Year 5 Monitoring Report FINAL

Hudson Property

RE: Draft Year 5 Monitoring Report for Hudson Property Stream Restoration Project (95361)
Tar-Pamlico River Basin; CU 03020105; Beaufort County, NC
Contract No. 004638

Ecotone has received comments from NCDEQ dated December 11, 2020 pertaining to the Draft Monitoring Year 5 Report for the Hudson Property. The accompanying submittal has been revised to reflect our responses to all comments and all information requested. Below are Ecotone's responses below to the received comments.

Cross Section 6 – Reach 2

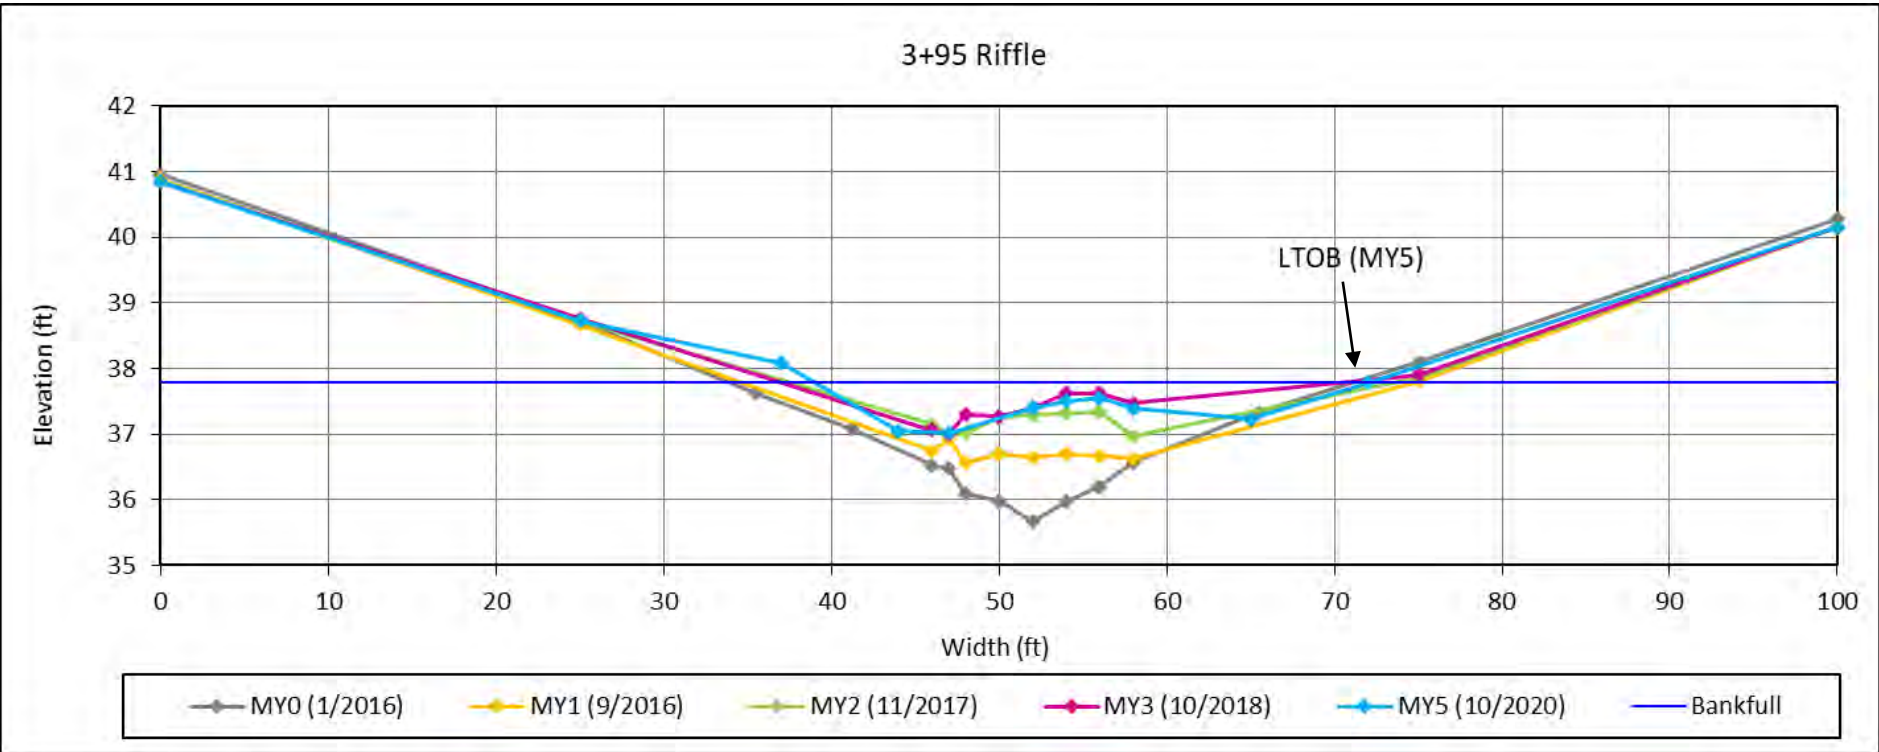
a. Please verify geomorphic data for cross section 6. LTOB Cross Sectional Area changed from 2.66 ft² in MY3 to 13.89 ft² in MY5. Also BHR went from 0.74 in MY3 to 1.60 in MY5. We recommend consideration be given to adding a line or point identifying the current monitoring year LTOB on the Cross Sections with Annual Overlays charts. This is useful for us when reviewing cross section data. *ECOTONE RESPONSE: A revision was needed in the "omit bankful" checkbox of the survey overlay file. This slightly decreased BHR and LTOB Cross Sectional Area, though they are still higher than previous years. This is likely because after a few years of aggradation, the channel has degraded slightly. An arrow indicating the Year 5 LTOB has been added to the cross section 6 chart.*
